TENNESSEE VALLEY AUTHORITY

WATTS BAR NUCLEAR PLANT (WBN) - RESISTANCE TEMPERATURE DETECTOR (RTD) BYPASS LOOP ELIMINATION AND EAGLE 21 ELECTRONICS UPGRADE - STATUS UPDATE

WATTS BAR NUCLEAR PLANT (WBÑ) - UNITS 1 AND 2  
RTD BYPASS ELIMINATION - RESPONSE TO NUCLEAR REGULATORY  
COMMISSION'S (NRC) REQUEST FOR ADDITIONAL INFORMATION

WAT/WBT THERMOWELL STRUCTURAL EVALUATION

Fig. 1 COLD Leg Thermowells

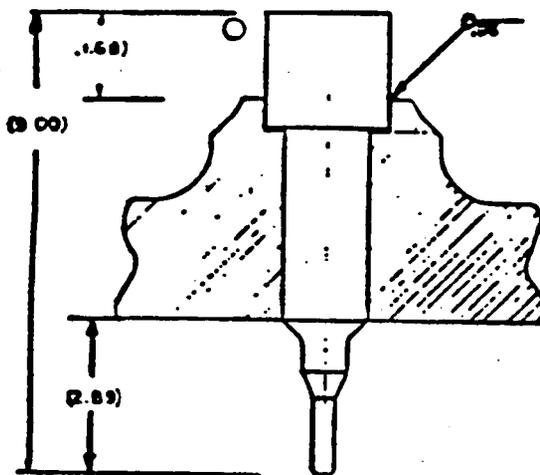
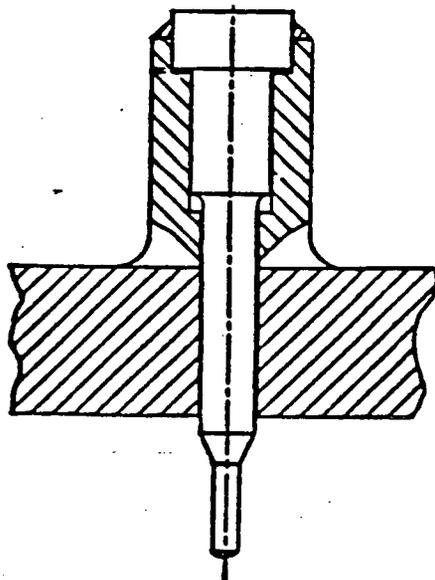
Q.2 The staff requires more information relative to the structural integrity of the narrow range and wide range Reactor Coolant System (RCS) temperature sensors (RTDs) which will be mounted in thermowells that protrude into the RCS hot and cold legs (Reference letter from J. A. Domer to Director of NRR, "Watts Bar Nuclear Plant - RTD Bypass Loop Elimination/Utilization of Eagle 21 Electronics - FSAR Chapters 5 and 7," dated December 1, 1986). Provide a description and summary of results of

analyses and/or tests which were performed to demonstrate that the proposed thermowells will withstand all anticipated flow induced vibration loads in combination with all other loads which are identified in applicable portions of FSAR Section 3.9.3. Include a discussion of the possibility of thermowell wear and high cycle fatigue damage which could be caused by turbulent buffeting and/or vortex shedding. Describe what post-installation tests, if any, would be performed to ensure that acceptable margins exist to prevent local fluid flow velocities from producing turbulent flow loads in resonance with the natural frequencies of the temperature probes.

- A.2 See attached report, entitled, WAT/WBT Thermowell Structural Evaluation, dated July, 1987, Revision 1. This report describes and summarizes the analyses performed to demonstrate the structural adequacy of the thermowells when subjected to pressure loadings, hydraulic steady flow loads, vibratory loads due to turbulent buffeting, vortex shedding, pump pulsations and seismic excitations, and post-installation tests are not considered to be necessary.

From the thermowell geometries shown above, it is obvious that the most critical sections are the root of the 0.4" tip sections where the thickness are the smallest. Therefore, it is suffice to analyze the stresses at this section only.

FIGURE 2  
DESIGN, VERIFICATION AND VALIDATION PROCESS

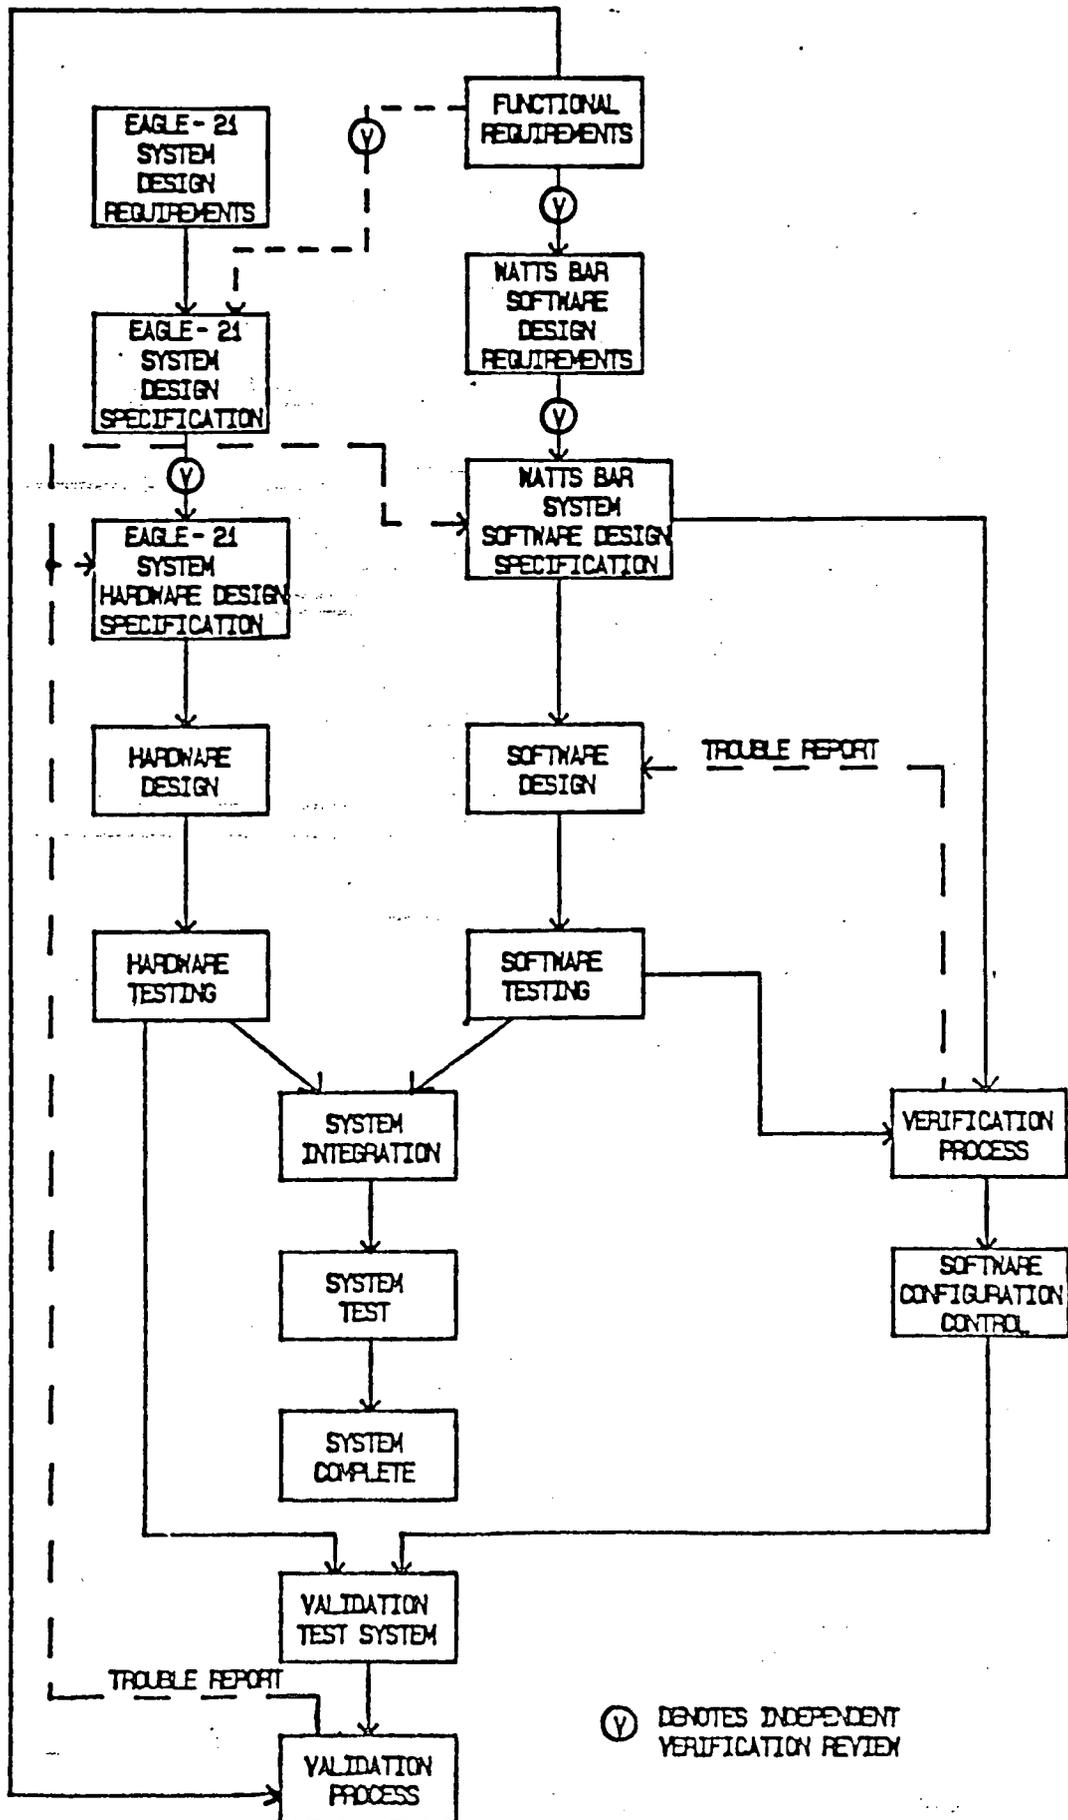
The Eagle-21 Design, Verification, and Validation Plan does not appear to provide for acceptable independence during the software verification process.

On page 10 of the referenced Audit Report on Verification and Validation Plan for the Eagle-21 System Utilization, dated April 27, 1987, it is stated, "The staff believes that the requirements of Appendix B of 10 CFR 50 take precedence over standards cited by the manufacturer in this area. Appendix B states in part that persons and organizations performing quality assurance functions shall report to a management level such that the required authority and organizational freedom include independence from cost and schedule."

Figure 2 illustrates the integration of the system verification and validation process with the system design process. The verification process may be divided into two distinct phases: verification of design documentation, and verification of software.

As shown on figure 2, independent verification of design documentation is performed during the design stage. For example, independent verification will occur to ensure that the translation from the Functional Requirements to the Software Design Requirements has been performed properly and thoroughly.

Figure 2 illustrates where an independent review and signoff will be conducted during the design process. Verification of the design documentation will be completed prior to the implementation and test phase.
